**BURLINGTON
RESOURCES**

Re: Hanks #5R
295'FSL, 560'FWL, Section 7, T-27-N, R-9-W, San Juan County, New Mexico
30-045-not assigned

Burlington Resources is applying for administrative approval of an unorthodox gas well location for the Fulcher Kutz Pictured Cliffs pool. This application for the referenced location is due to terrain in the Badlands, the presence of the endangered gillia formosa plant.

Re: Application for administrative approval to drill the Hanks Well No. 5-R at an unorthodox gas well location 295 feet from the South line and 560 feet from the West line (Lot 4/Unit M) of Section 7, Township 27 North, Range 9 West, NMPM, Fulcher Kutz-Pictured Cliffs Pool, San Juan County, New Mexico.

WELL LOCATION PLAT

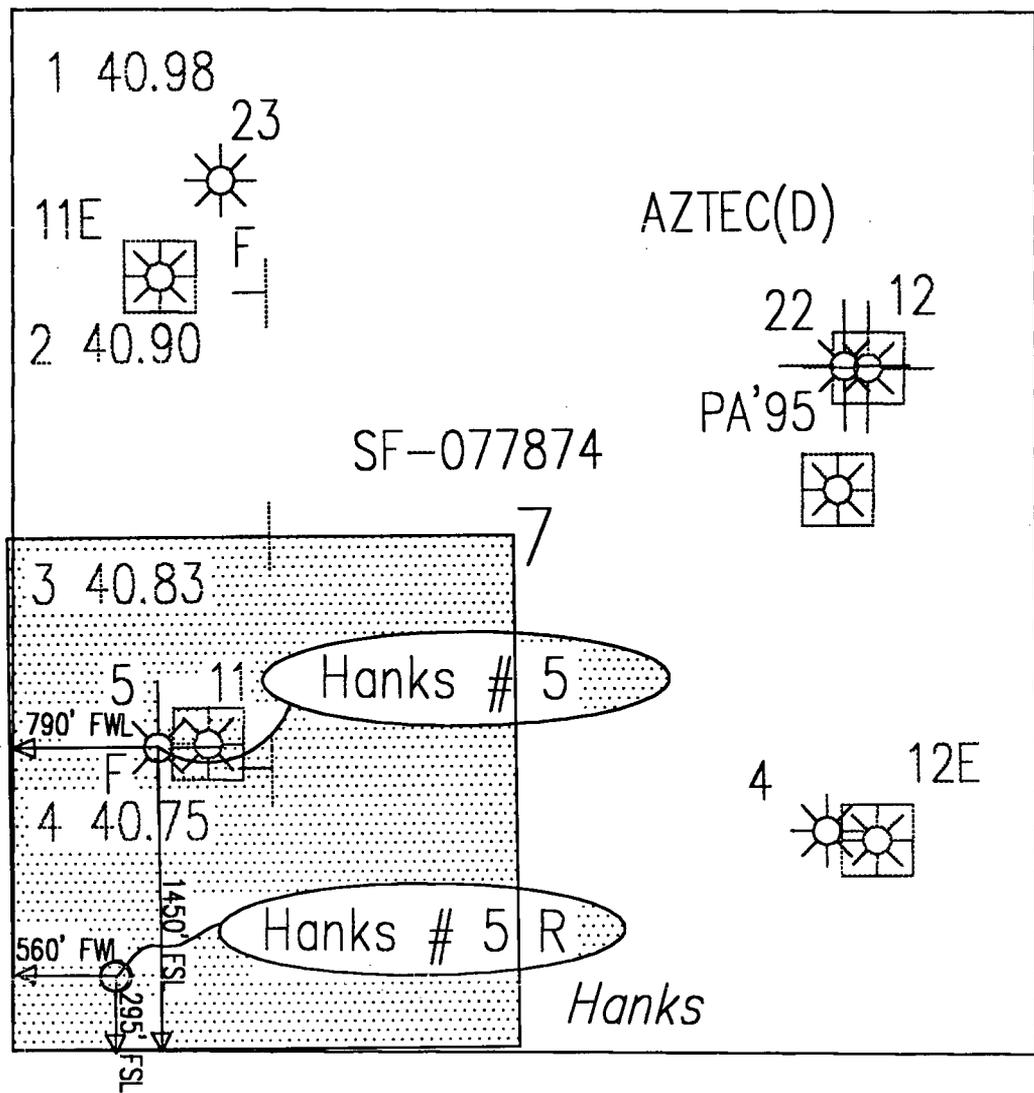
The designation "R" in a well number usually signifies this well to be a replacement well. Your application gave no information or indication that this was the case. Please submit a brief clarification of this matter and provide any additional information by way of maps, plats, and copies of pertinent information from well files to supplement this request. Since the Fulcher Kutz-Pictured Cliffs Pool is not a "prorated gas pool," does Division General Rule 104.D(3) affect this 160-acre spacing unit?

Per your request, attached is a map showing the proposed non-standard location for the subject well. This map also shows the other wells in Section 7, T-27-N, R-9-W.

The Hanks #5 (30-045-06642) was originally drilled and completed at 1450'FSL, 790'FWL as a single Fulcher Kutz Pictured Cliffs well in 1952. In October 1990, the Pictured Cliffs pool was temporarily abandoned with a cast iron bridge plug, and the Fruitland Coal pool was opened. The Hanks #5 has produced from the Fruitland Coal only since 1990.
